Update on EPoC Upstream Pilot Proposal

RBs and Pilot Patterns

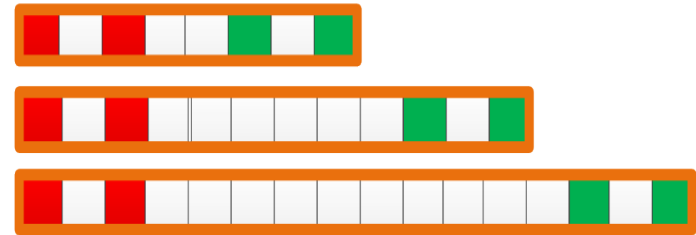
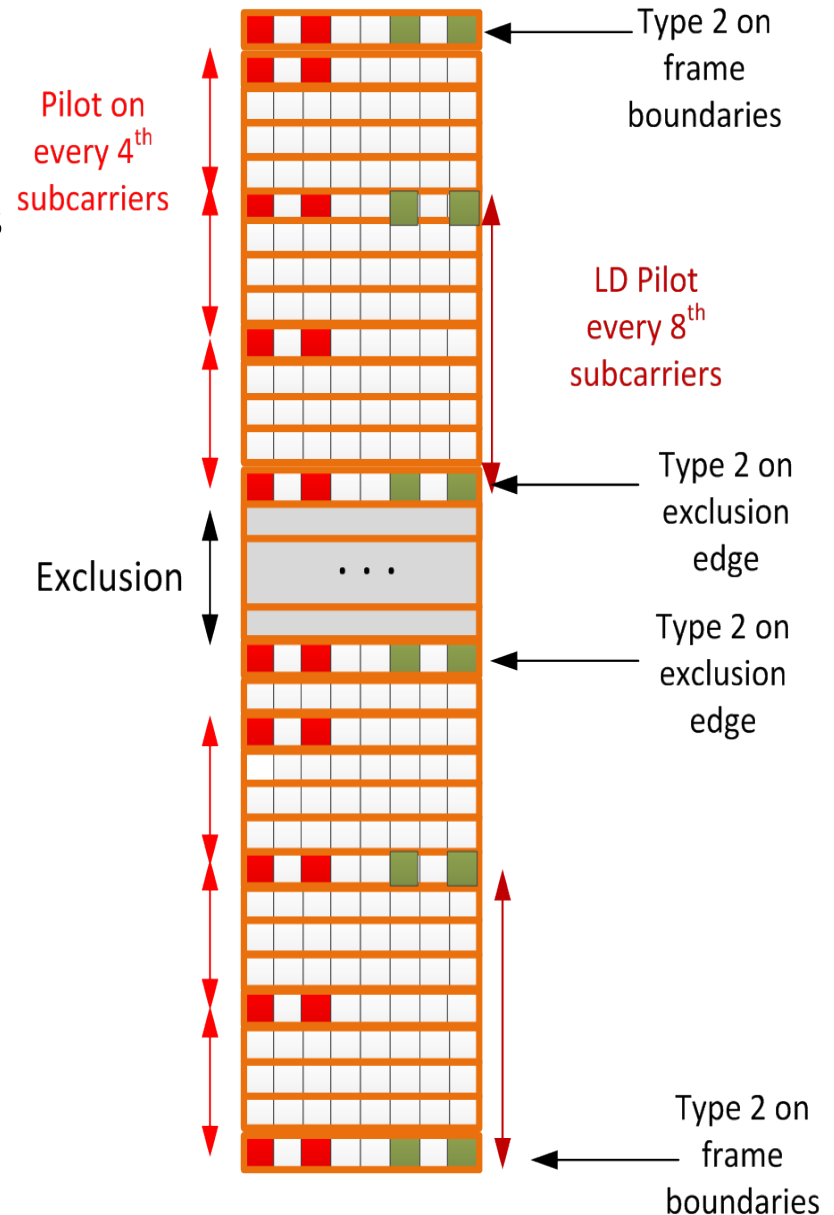
- Three types of RBs
 - Type 0 – RB does not include pilots
 - Type 1 – RB includes two pilots
 - Type 2 - RB includes two pilots and two low-density data subcarriers (“LD pilots”)
 - How low density is LD? 1, 2 bits less? State clearly.
- Figure below depicts RB type 1 and Type 2 with 8,12 and 16 symbols

Pilot Rules – Examples (2)

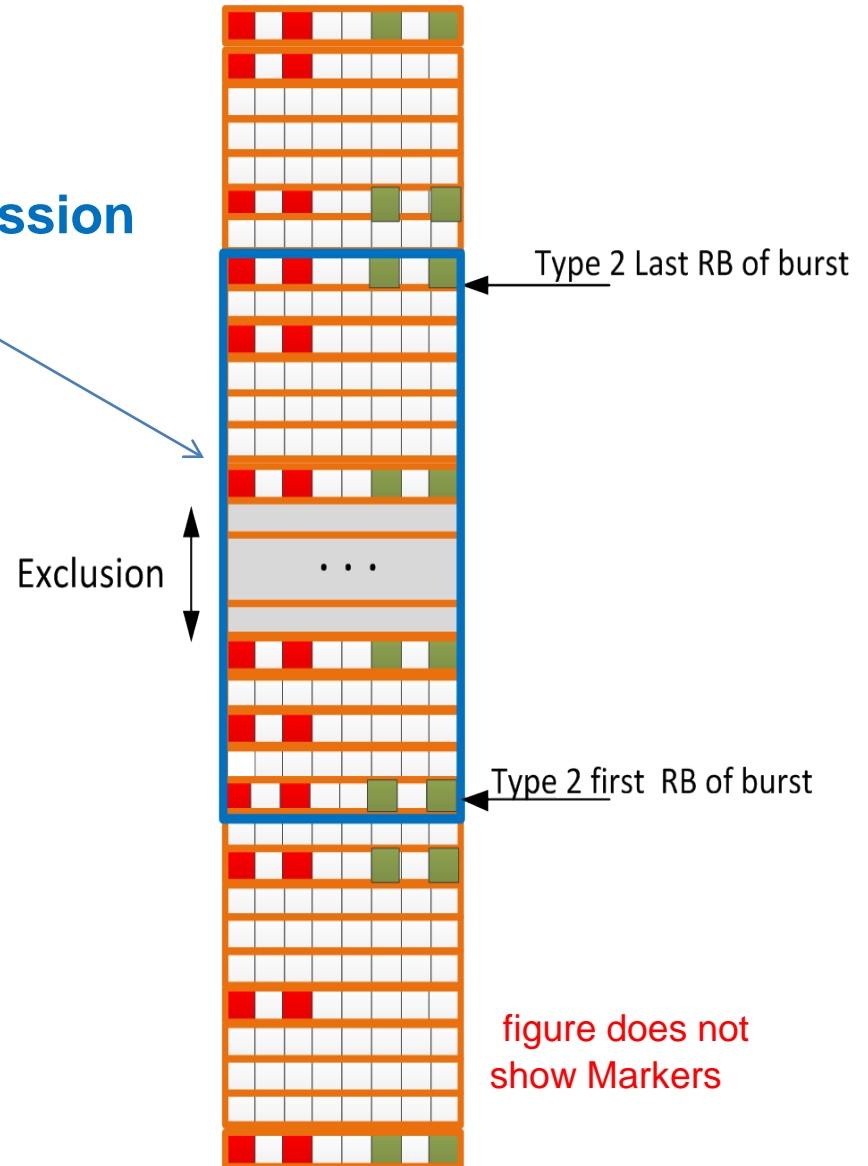
- A transmission burst starts and ends with a Type 2 RB **Transmission burst**
- These pilots are added over the fixed pilot pattern
- When a start or end “lands” on a Type 1, does it then become a Type 2? How do markers align? and with LD use?
- Why do start/stop pilots necessary? Make part of marker definition (floating) and not part of pilot definition (fixed)?
